HaskoningDHV UK Ltd.
Industry & Buildings

To: Marine Management Organisation
From: Royal HaskoningDHV (Steven Rayner)
Date: 16 March 2021
Copy: Tees Valley Combined Authority
Our reference: PC1084-RHD-SB-EN-CO-EV-1116
Classification: Project related
Checked by: Royal HaskoningDHV (Matt Simpson)

Subject: South Bank Quay marine licence applications - responses to Cefas comments

Figure Error! No text of specified style in document..17 Location of points around the offshore disposal site used for of timeseries analysis of changes in SSC and sediment deposition (reproduced from ES chapter)

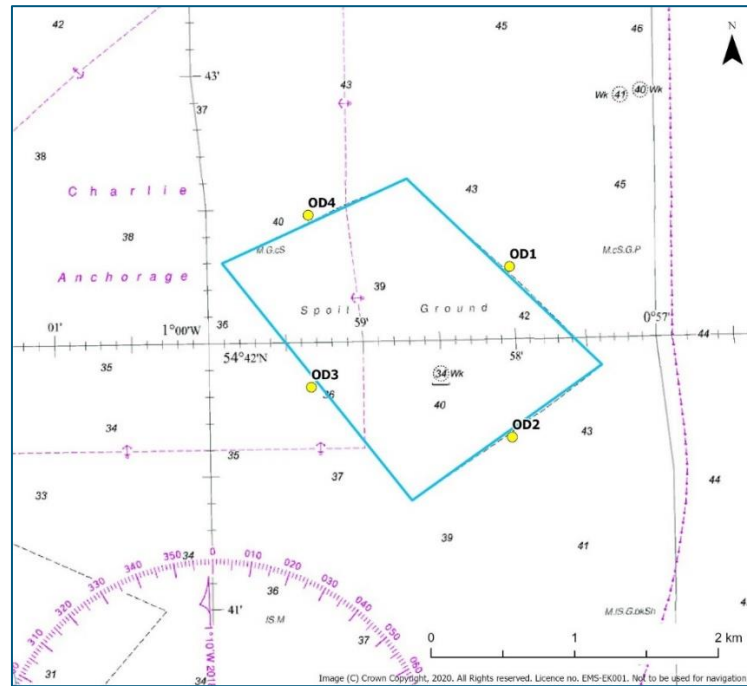
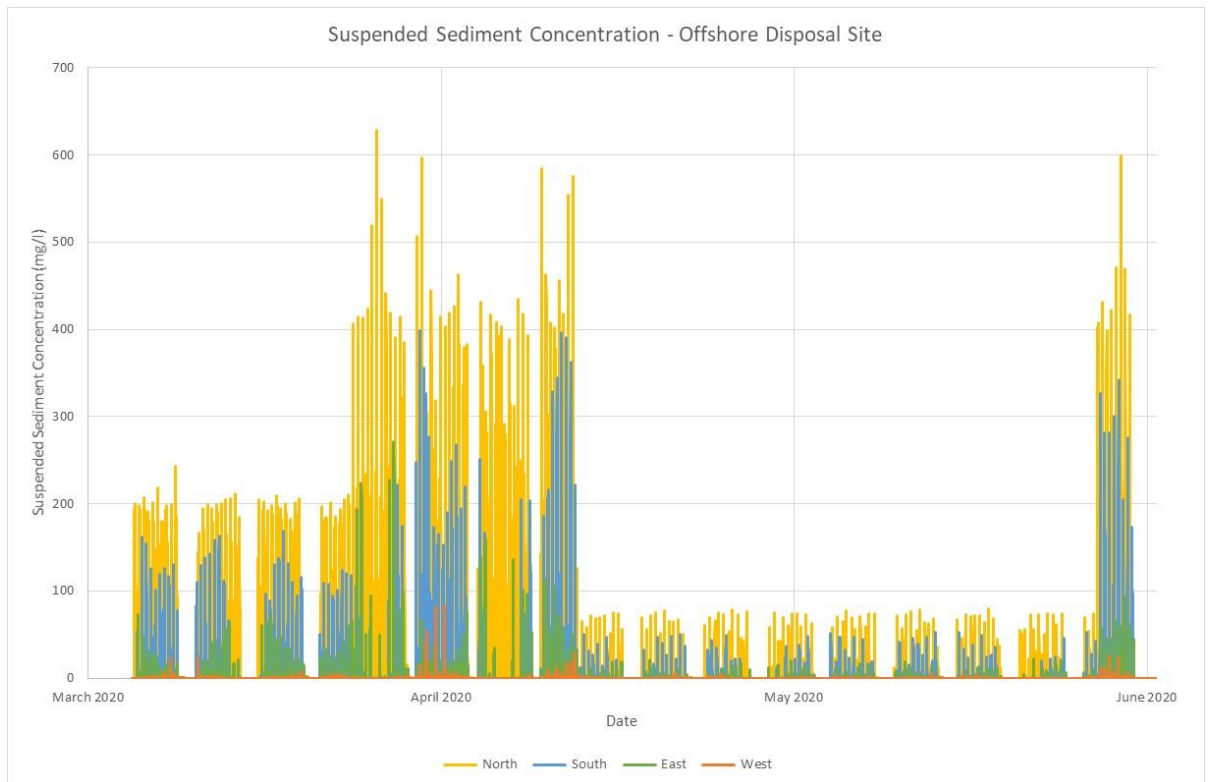
Disposal assessments do not present the maximum bed thickness change due to the sediment disposal, though this would be the most important coastal process impact. In contrast to all other data presented, deposition at the disposal site is presented for a single disposal event only (Figure 6.65), but the key data required is the maximum total bed level change from the cumulative disposal of the entire dredge load. This should be presented and discussed with respect to the licensed disposal site.

Cefas has requested that the maximum total bed level change from the cumulative disposal of the entire dredge load be presented and discussed with respect to the licensed disposal site. Given the modelling that has already been undertaken, with all disposal releases from a common point, we can easily extract a timeseries of changes in bed thickness at the four 'timeseries analysis' points (the location of which is shown in Figure 6.67 of the chapter) to correspond with the timeseries plot of changes in SSC that was presented in Figure 6.68 of the chapter. For ease of reference, these two figures are reproduced below, with the corresponding bed thickness change plot newly added below as an additional figure.

Figure Error! No text of specified style in document..68 Timeseries of changes in SSC at the offshore disposal site monitoring points (reproduced from ES chapter)

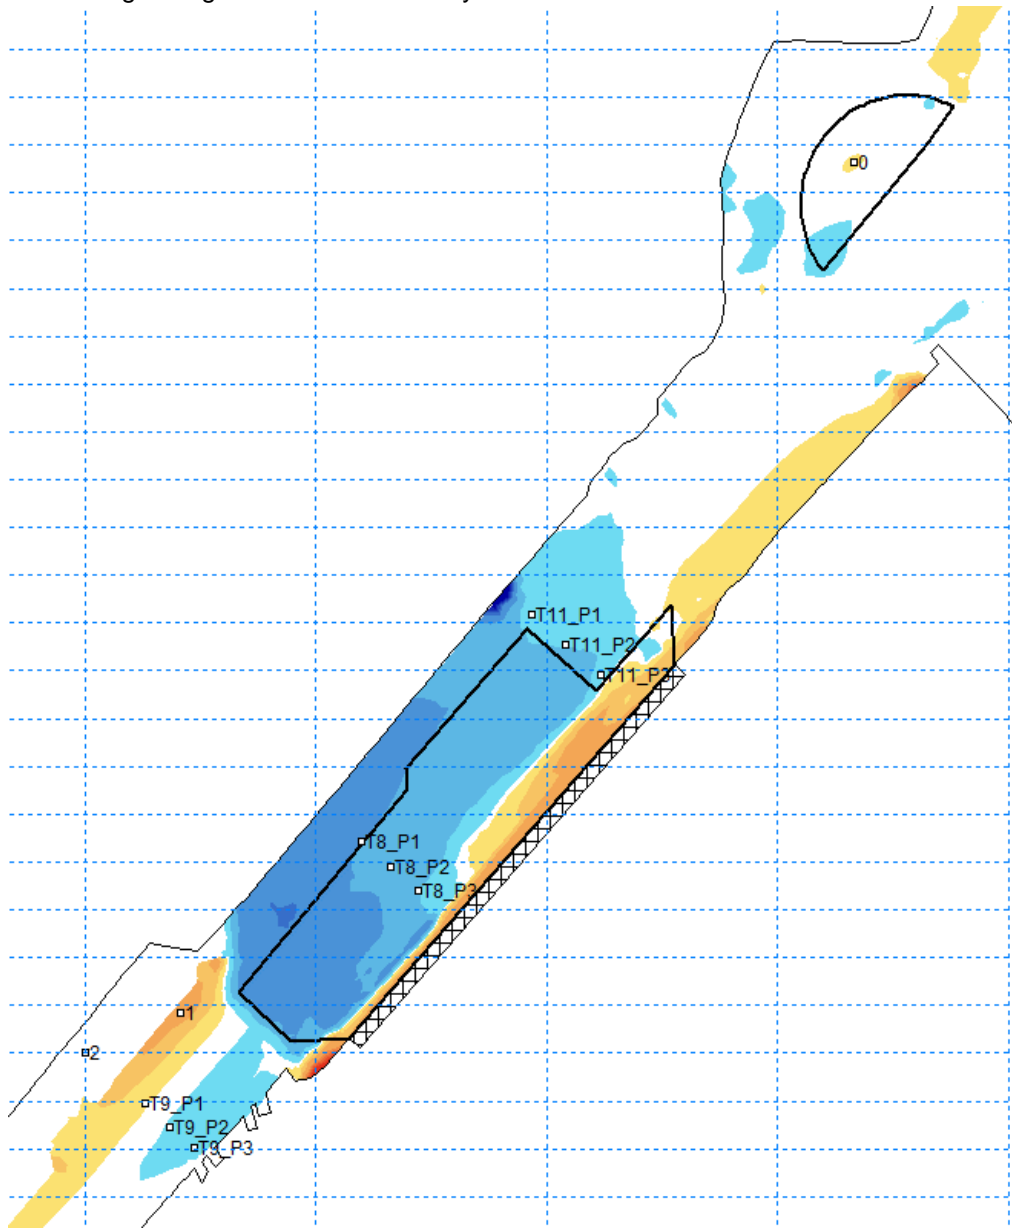
Flow speeds due to scheme are described as being reduced by ‘only’ 5-10cm/s, but this is not discussed in terms of actual flow speeds at the site, and it appears that this may be up to 50% reduction? Dredging of the turning circle is also reported as having no hydrodynamic impact, which seems counter-intuitive. The applicant should provide a clear description of the baseline case and indicate the magnitude of the change relative to the present. The dredged pocket and area of affected flows appears to occupy the full width of the channel and therefore may have consequences on both banks, leading to a possible long-lasting change, in turn affected by future climate-induced changes. Cefas are concerned that you have not justified your conclusions of the significance of this specific impact sufficiently.

The modelling results show that (mostly) reductions in flow will be confined to the reach of the estuary containing the proposed dredging/quay. The effect can, at some tidal states (but not all), be seen across the full width of the channel, as stated by Cefas.

2. We have not claimed that the dredging of the Tees Dock turning circle will have “no hydrodynamic impact”. We stated that there is no “measurable change”. There is a change within the turning circle, but the change is less than $\pm 0.05\text{m/s}$ and so not displayed on the plot.
3. Given Cefas’ concern that we have not justified our conclusions of the significance of these specific impacts sufficiently, we have extracted further timeseries results from the model at:
 - a. three points along each of transects 11 (downstream), 8 (at site) and 9 (upstream)
 - b. two points at the North Tees Mudflat
 - c. one point from the Tees Dock Turning Circle.

Additional figure
quay area only

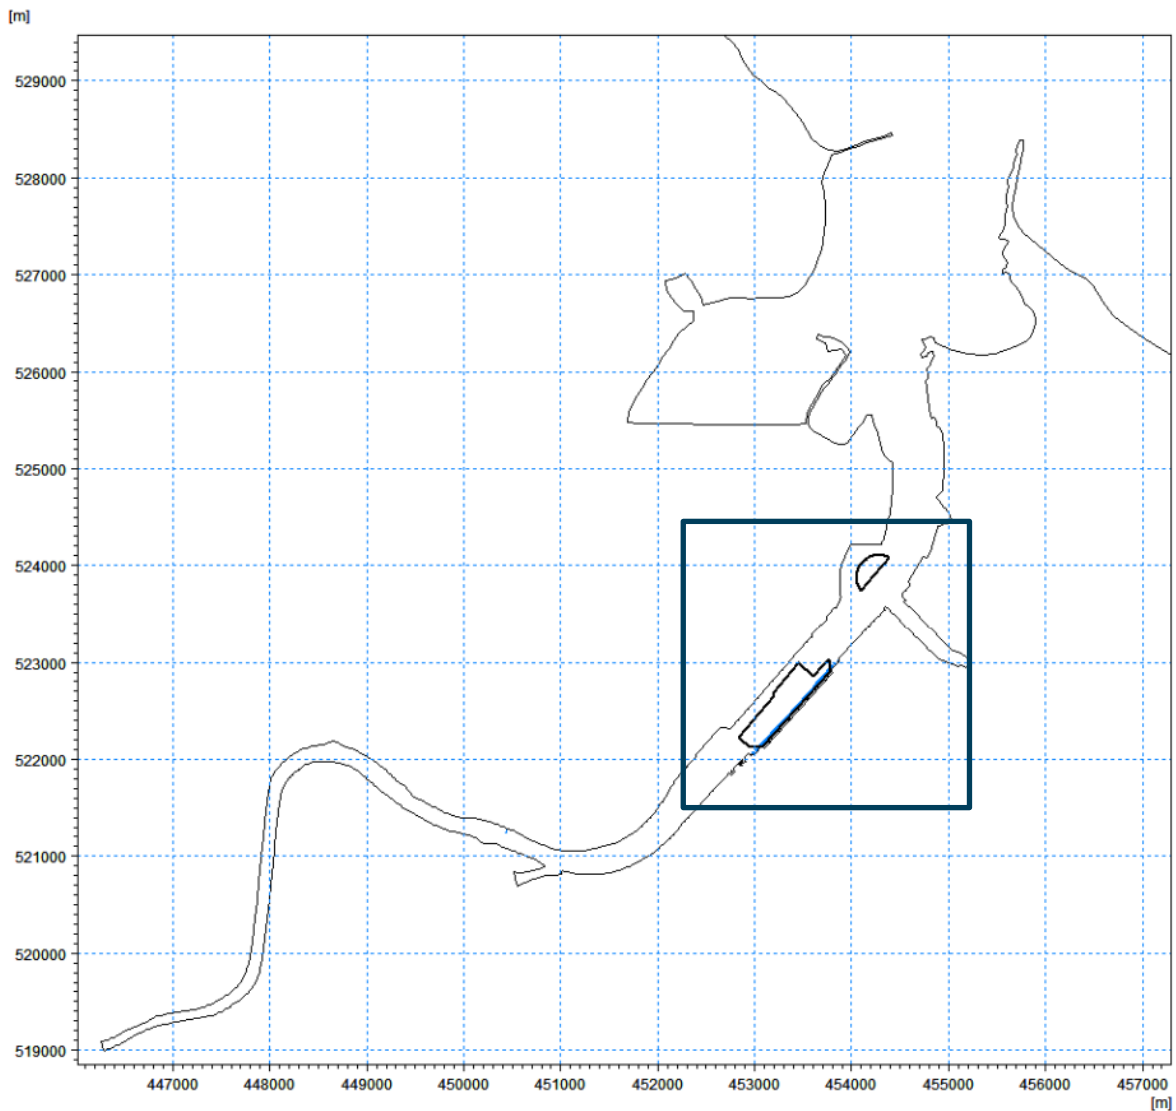
It is stated that there is predicted to be an increase in the tidal prism of 0.8% and that this is considered to be of low magnitude. However, while a prism change of 0.8% may seemingly appear small, there is no

evidence to indicate what effect this 0.8% change will have on the extent of intertidal vs subtidal area. Is there any evidence of this in the EIA report to quantify this which may therefore be used to support the conclusion of low magnitude?

The change in tidal prism relates purely to the addition of an area of both sub-tidal and inter-tidal within the newly created 'pocket' to be created as part of the proposed scheme. There will be no change in hydrodynamics due to the scheme which will lead to changes in tidal prism elsewhere (e.g. water level changes which will alter the extent of inter-tidal prism /area).

To demonstrate this, we have extracted the following plot from the existing model, showing water level changes within the newly created quay, but no change elsewhere.
